## Product Change Notification

Document No. **PCN-A-20230216** Revision **1.0**

To improve our panel PC, Winmate has upgrade new platform for marine Panel PC to 11<sup>th</sup> generation Tiger Lake.

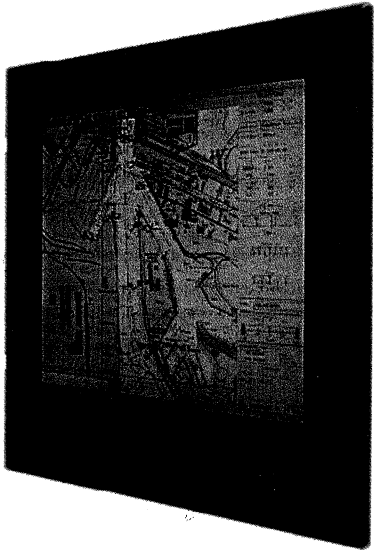
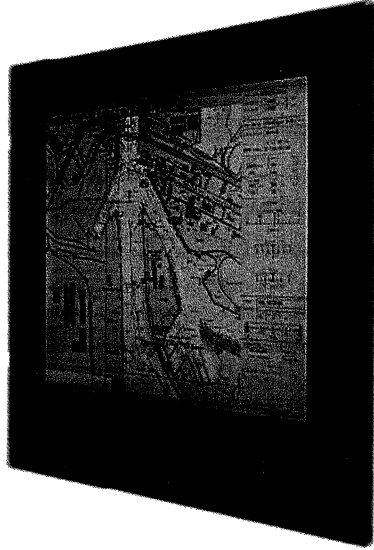
Due to new platform for marine Panel PC using IT Series, the IV series Panel PC will discontinuance.

<b>Original</b>	<b>New</b>
None	R12IT3S-MRM2
R15IV3S-MRM2	R15IT3S-MRM2
R17IV3S-MRM1	R17IT3S-MRM1
R19IV3S-MRA2	R19IT3S-MRA2
W24L100-MRA1IV3S	W24IT3S-MRA1

<b>CPU</b>	Intel Core i7-3517UE 1.7GHz (up to 2.8GHz)	Intel Core i7-1165G7 2.8GHz (up to 4.7GHz)
<b>Size</b>	15", 17", 19", 24	12", 15", 17", 19", 24
<b>RAM</b>	1 x SO-DIMM, DDR3L 1600 MHz, 4GB 8GB (Optional)	1 x SO-DIMM, DDR4 2400 MHz, 4GB up to 32GB

SSD	1 x mSATA SSD 128GB mSATA SSD up to 512GB (Optional)	1 x M.2 2242 B-key SSD 64GB  M.2 2242 B-key SSD up to 512GB  M.2 2280 M-Key NVME SSD, up to 4TB
OS	Windows 7 Embedded Systems Windows 10 IoT Enterprise Linux Ubuntu 18.04	Windows 10 IoT Enterprise Windows 11 IoT Enterprise Linux Ubuntu 22.04
Power Rating	24V DC-in with Isolation (Approval by Certificate) 9~36V DC Input Acceptable	24V DC-in with Isolation (Approval by Certificate) 9~36V DC Input Acceptable
Dimension	Same	Same
IO Port	Same	Same
